# Access Compliance Report

### (Curb Ramps)

Intersection ID: 10011612	Main Street: UNIVERSITY_CITY_BV	Cross Street: N/A	Location: S
ADA ID: 90E0F038DA56	Ramp Type: Perp	Initial Pass/Fail: Fail	Overall Compliance: No
Severity Score: 8.75			
Codes/Mitigation Info/Possible Solution		Field Measurements/Component Compliance

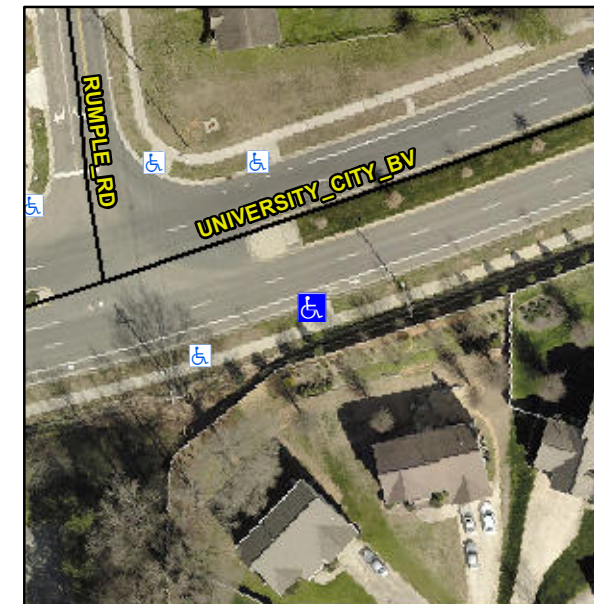
**Not Found, R304.5.1**

Compliance	Description	Data	Compliance	Description	Data
N/A	Ramp Length (in)	96.0	Yes	Ramp Slope (%)	7.6
No	Ramp Width (in)	47.0	Yes	Ramp XSlope (%)	0.8
N/A	Flare Type LT	N/A	N/A	Flare Type RT	N/A
N/A	Flare Slope LT (%)	N/A	N/A	Flare Slope RT (%)	N/A
N/A	Flare Traversable LT?	N/A	N/A	Flare Traversable RT?	N/A
N/A	Landing Length (in)	N/A	N/A	DWS Provided?	N/A
N/A	Landing Width (in)	N/A	N/A	DWS Contrast?	N/A
N/A	Landing Slope (%)	N/A	N/A	DWS Length (in)	N/A
N/A	Landing X Slope (%)	N/A	N/A	DWS Full Width?	N/A
N/A	Landing Curb? (Y/N)	N/A	N/A	DWS Offset (in)	N/A
N/A	Shared Landing?	N/A			
N/A	Gutter Ponding?	N/A	N/A	Gutter Slope (%)	N/A
N/A	Gutter Lip Ht (in)	N/A	N/A	Gutter X Slope (%)	N/A
N/A	Painted X Walk1?	No	N/A	Painted X Walk2?	N/A
	X Walk 1 Direction	To N		X Walk 2 Direction	N/A
N/A	X Walk 1 Width (in)	N/A	N/A	X Walk 2 Width (in)	N/A
	X Walk 1 Slope (%)	2.7		X Walk 2 Slope (%)	N/A
	X Walk 1 X Slope (%)	0.8		X Walk 2 X Slope (%)	N/A

**Remove & Replace Entire Ramp.**
